KNECHT SUBDIVISION

DSD FILE NO.: SF2419

FINAL PLAT
KNECHT SUBDIVISION

Sheet: 1 of 2

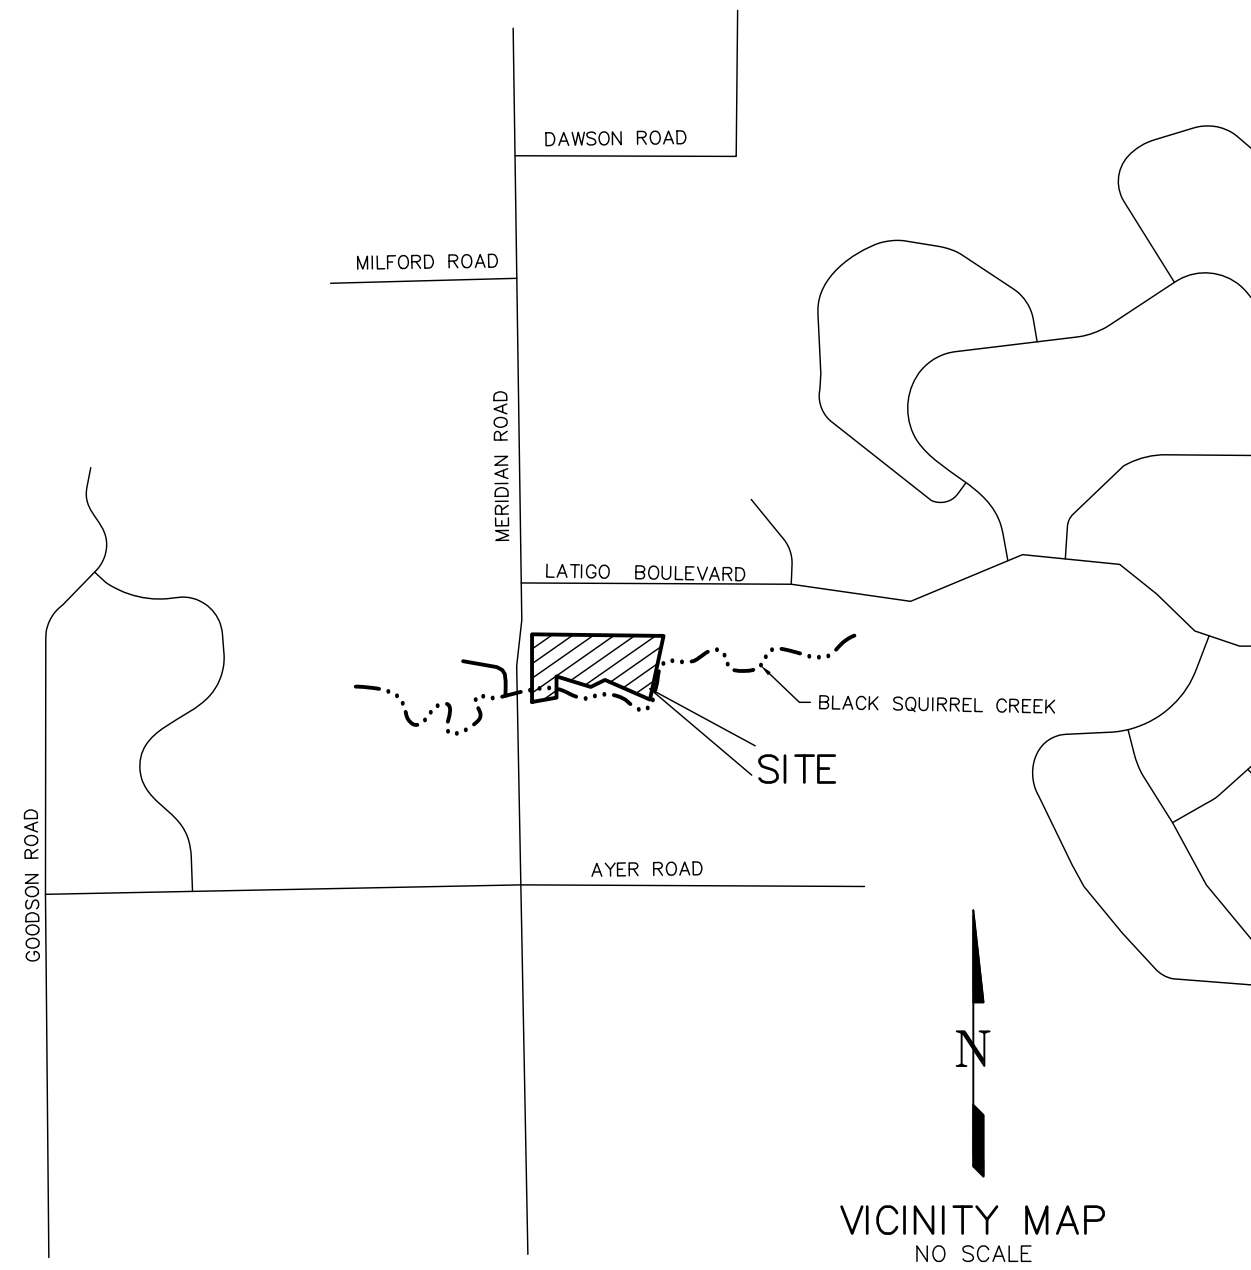
Please add the following notes:

Please include a note on this plat identifying the approved dimensional variance and BOA file number that allows the lot size for Lot 1.

Title commitment information will need to be updated

- All structural foundations shall be located and designed by a Professional Engineer, currently registered in the State of Colorado.
This is required to be a road - not a driveway
Provide a maintenance agreement

Delete this

Please identify the specific hazards and constraints and which lots they were prevalent on. Please use the standard note block language when crafting this note. Also identify the specific mitigation measures that will be employed on the property, as identified in the report.

"The Upper Black Squirrel Creek Groundwater Management District requires that any groundwater discharged to the surface or into an underdrain system must be infiltrated back into the ground. It is the developer's responsibility to comply with the UBSC district requirements."

No structures or fences are permitted within designated Floodplain areas.

The private roads as shown on this plat will not be maintained by El Paso County until and unless the streets are constructed in conformance with El Paso County standards in effect at the date of the request for dedication and maintenance.

Soil and Geologic Conditions:
Geologic Hazard Note-Final Plat: (to be customized based upon the individual circumstances)
The following lots have been found to be impacted by geologic hazards. Mitigation measures and a map of the hazard area can be found in the report (Title of Report, generally from the Preliminary Plan file) by (author of the report) (date of report) in file (name of file and file number) available at the El Paso County Planning and Community Development Department:
•Downslope Creep: (name lots or location of area)
•Rockfall Source: (name lots or location of area)
•Rockfall Runout Zone: (name lots or location of area)
•Potentially Seasonally High Groundwater: (name lots or location of area)
•Other Hazard:
In Areas of High Groundwater:
Due to high groundwater in the area, all foundations shall incorporate an underground drainage system.

Project No.: 18058
Sheet: 2 of 2

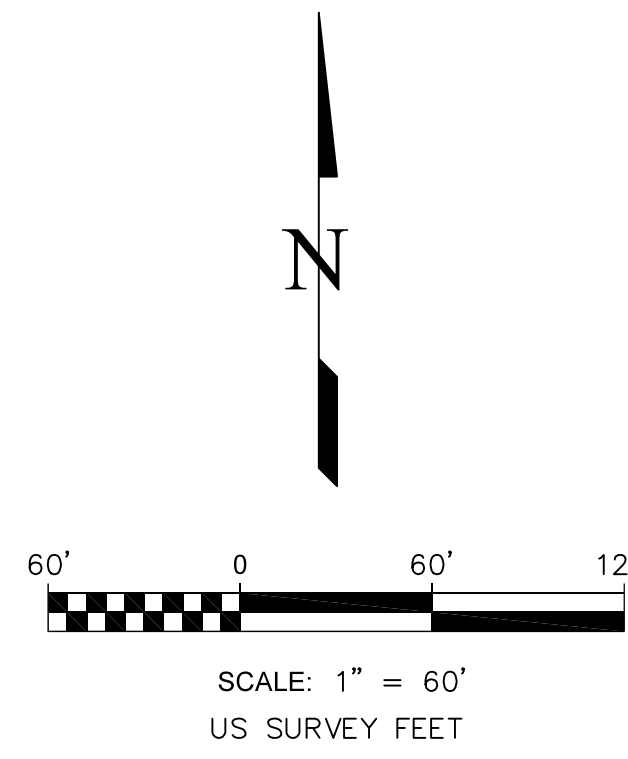
Meridian Road is a Minor Arterial with 100' of ROW required. Please provide for ROW dedication for 50' from the roadway centerline.

New private road easement will need to vacate this easement. Can't have two overlapping easements.

Indicate the width of the private road in the label and update the label to identify it as a road, not a driveway

What is the purpose of this easement if 20 ft is provided on the north side of the private road?

The driveway location on the drainage report is shown outside the easement. Please adjust private access easement so the driveway for lot 5 is included.

Per Engineering comment, this should be a 50 ft dedication, not a 30 ft reservation. Easement width will begin on the east side of the land dedication.

Can this part encroach into the transmission line easement?

This lot is not large enough, and will be even smaller after the right-of-way dedication. You may have 4.75 acres for the lot adjacent to Meridian Road, but all other lots must be greater than 5 acres. Right-of-way dedication shall be excluded from lot area measurements.
